Subject: RE: CUP17-03 Union Self Storage Facility **Attachments:** Sheet 1 Wetland Impacts and Mitigation.pdf

Subject: RE: CUP17-03 Union Self Storage Facility

Wetland Impacts and Mitigation

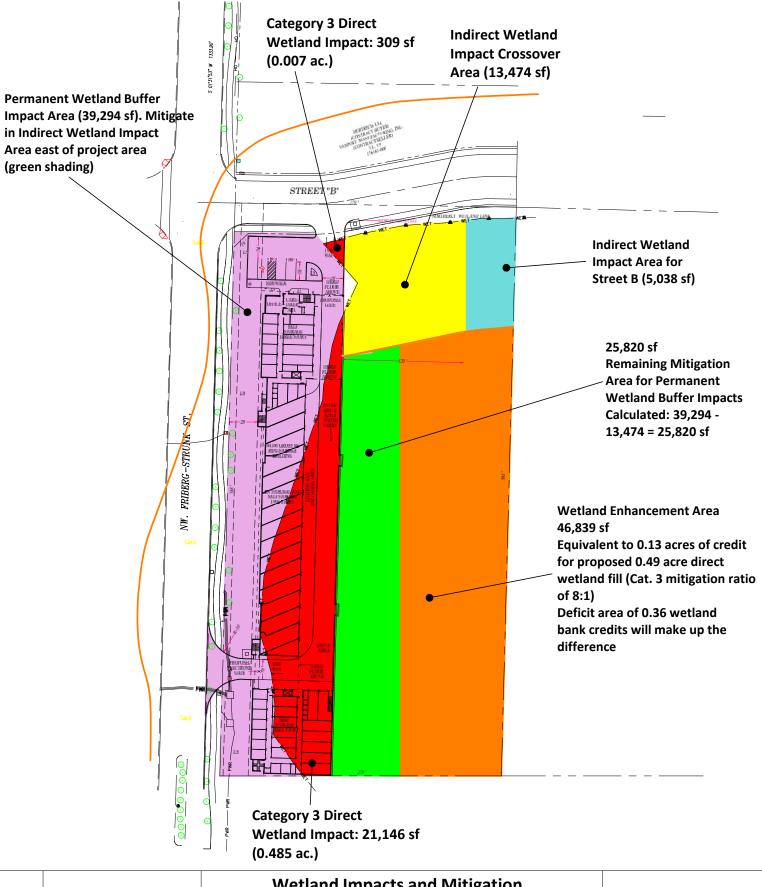
Permanent Wetland Buffer Impacts (City): The project will result in 39,294 sf (0.90 ac.) of permanent wetland buffer impacts (purple shaded area)

Direct Wetland Buffer Impacts (City, Corps, Ecology): The project will result in 21,455 sf (0.90 ac.) of direct wetland impacts (red shaded area)

Indirect Wetland Impacts (Corps, Ecology): The project will result in 5,038 sf (0.11 ac.) of indirect wetland impacts (cyan shaded area)

On-site Wetland Enhancement for Permanent Wetland Buffer Impacts (City): The yellow shaded area labeled as "Indirect Wetland Impact Crossover Area" (13,474 sf) and the green shaded area labeled "Remaining Mitigation Area for Permanent Wetland Buffer Impacts" equal the area of the permanent wetland buffer impacts which is 39,294 sf. This area will mitigated through wetland enhancement by planting native shrubs and trees as required by code.

On-Site Enhancement for Direct Wetland Impacts (City): In order to mitigate for direct wetland impacts, the orange shaded area will be mitigated through wetland enhancement by planting native shrubs and trees. This area is 46,839 sf in size. The Ecology mitigation ratio for wetland enhancement is 8:1. Therefore, 46,839 sf / 8 = 5,854 sf. That results in a credit of 0.13 acres out of the 0.49 acre direct wetland impact.

Wetland Mitigation Bank (City, Corps, Ecology): The applicant will purchase 0.36 credits from the Terrace Wetland Mitigation Bank to account for the remaining direct wetland impacts. 0.49 ac -0.13 ac. credit for on-site wetland enhancement = 0.36.
